September 7, 2016

RE: **Valero Residence**
Lot 4 Block 5 Unit 22 SAD 228
6308 Papagayo NW
Grading and Drainage Plan
Engineers Stamp Date 8/9/16 (D10D003V4)

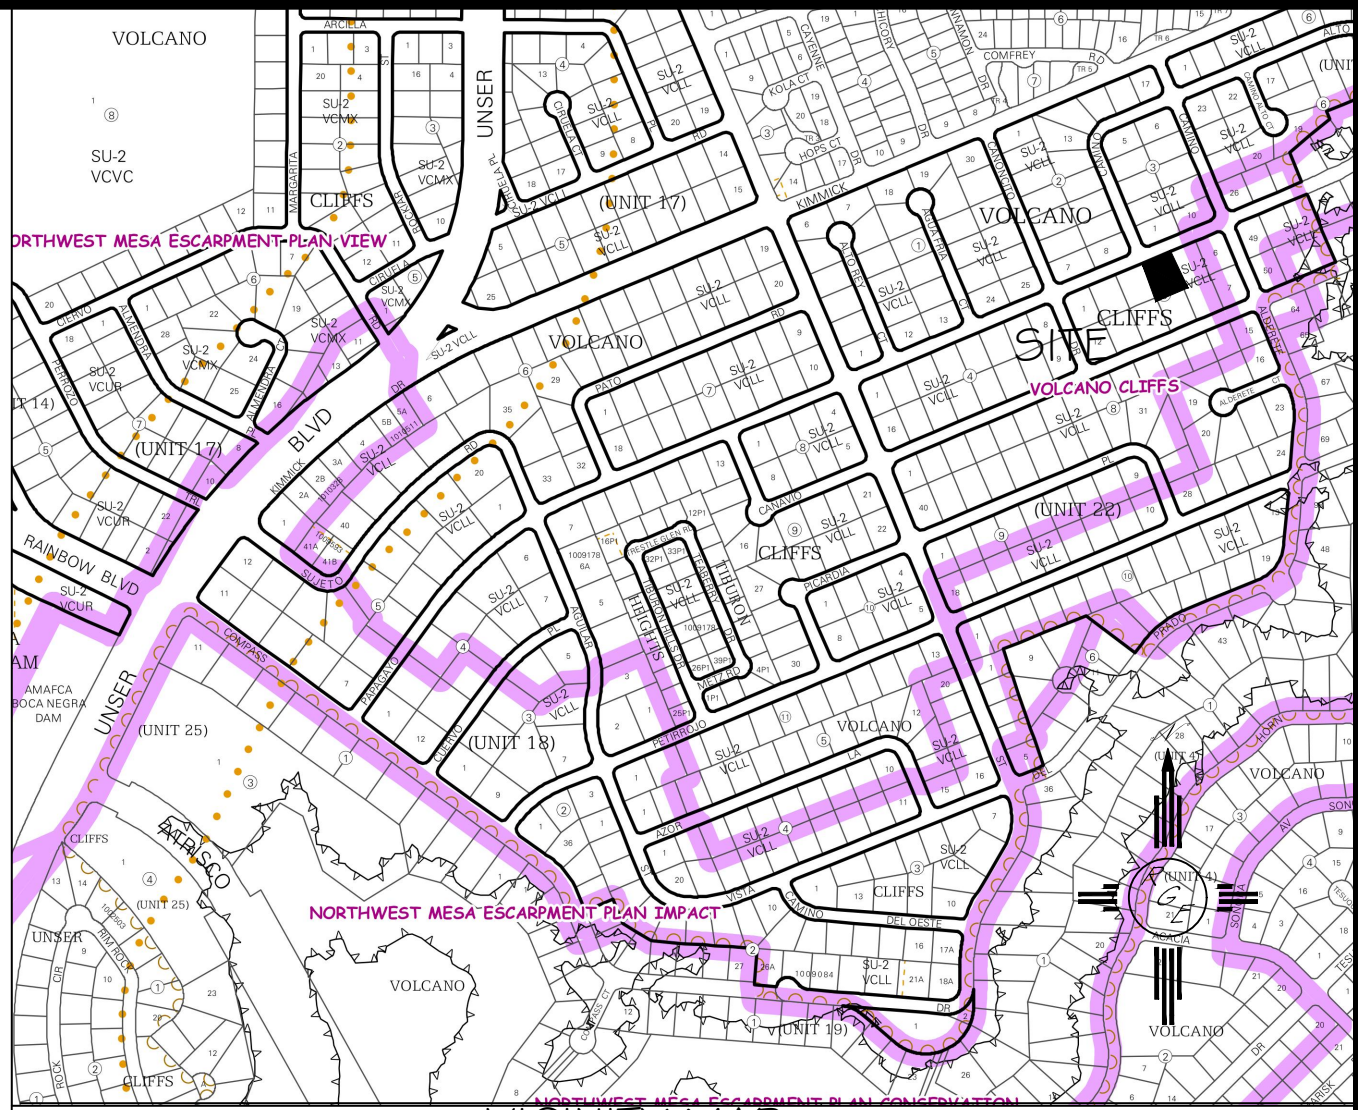
Based upon the information provided in your submittal received 8/12/16, this plan is approved for Grading Permit and Building Permit.

Please inform the builder to attach a copy of this approved plan to the construction sets in the permitting process prior to sign-off by Hydrology. Also, notify the owner/contractor that a separate permit for the fence is required.

Prior to Certificate of Occupancy release, Engineer Certification per the DPM checklist of this plan will be required.
